*Comments on the WaterSense®
Draft Specification for Soil Moisture-Based
Irrigation Control Technologies*

February 6, 2020

Figure: Plot Showing Calculation of Relative Average Deviation

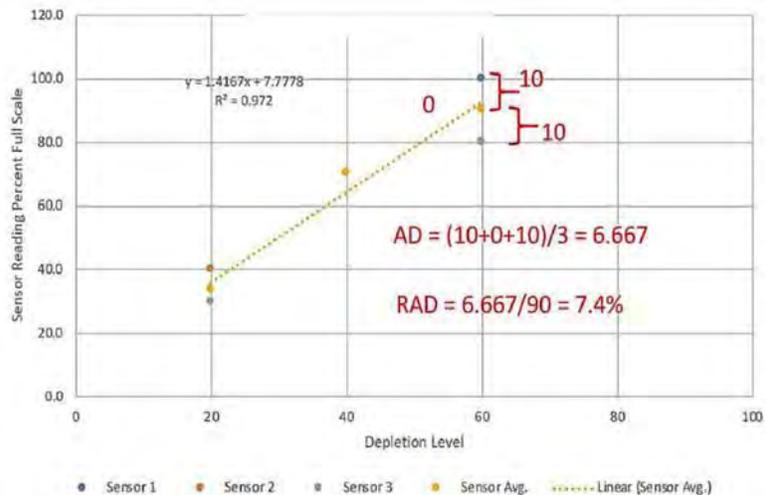
Topic 1: Clarify the calculation of relative average deviation (RAD) as shown on slide 35 of webinar presentation and section 2.2.1.2 of the draft specification.

The draft specification says that the RAD will be averaged across all water depletion levels. The WaterSense Draft Specification for Soil Moisture-Based Irrigation Control Technologies (November 20, 2019) webinar slide 35 shows that the RAD should be calculated at each water depletion level (20 percent, 40 percent, and 60 percent). The webinar and the draft specification seem to be inconsistent.

The calculation of the average RAD across all water depletion levels could be made clearer by adding Equation (3) to the specification.

The draft specification must also define the units of the performance criteria. The webinar suggests the units are “sensor reading percent full scale.”

Equation (3): $RAD_{avg} = (RAD_{20} + RAD_{40} + RAD_{60}) / 3$

Source: U.S. EPA WaterSense Webinar, November 20, 2019, Slide 37

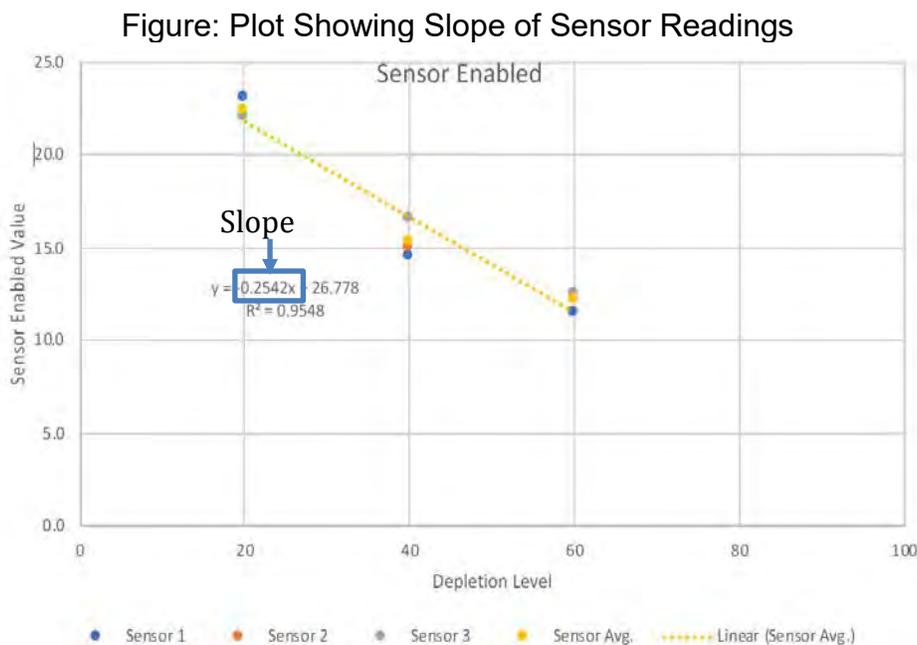
Topic 3: The sensor readings and calculation methods in section 2.2.1.3 need to be identified.

The draft specification provides this instruction to find the slope as a verification of the device performance. The draft does not identify the readings or describe how the three readings at each of the three water depletion levels are used to calculate the slope.

The EPA must identify the irrigation enable and irrigation disable readings to remove ambiguity. Are the readings a sensor value presented as a percentage of full scale? Is the reading a resistance, a current or voltage? What units are used to record the reading? If the reading varies among the soil moisture sensing technologies, then the specification must define the differences.

The calculation result is sensitive to the units of the readings’ measurement. The performance criteria should be expressed in the desired units. If the readings are in ohms then the criteria would be expressed as >0.01 ohms per percent water depletion.

If units of measure vary among the soil moisture sensing technologies, then the specification must define the units of the performance criteria for each technology.

The draft specification must define the vertical axis as the sensor reading and the horizontal axis as the water depletion level so the slope can be calculated consistently.

The draft specification must define how the depletion level percentage is represented when the calculation is performed. For example would “20” or “0.2” be used to represent 20 percent when the slope is calculated?

The draft specification does not provide a calculation method for the slope of the line. Slide 37 of the webinar presentation shows a Microsoft Excel plot where the slope is observed as the coefficient of the “x” value of the linear least squares fit of the data. The draft specification must identify the linear least squares fit as the calculation method to ensure consistency.
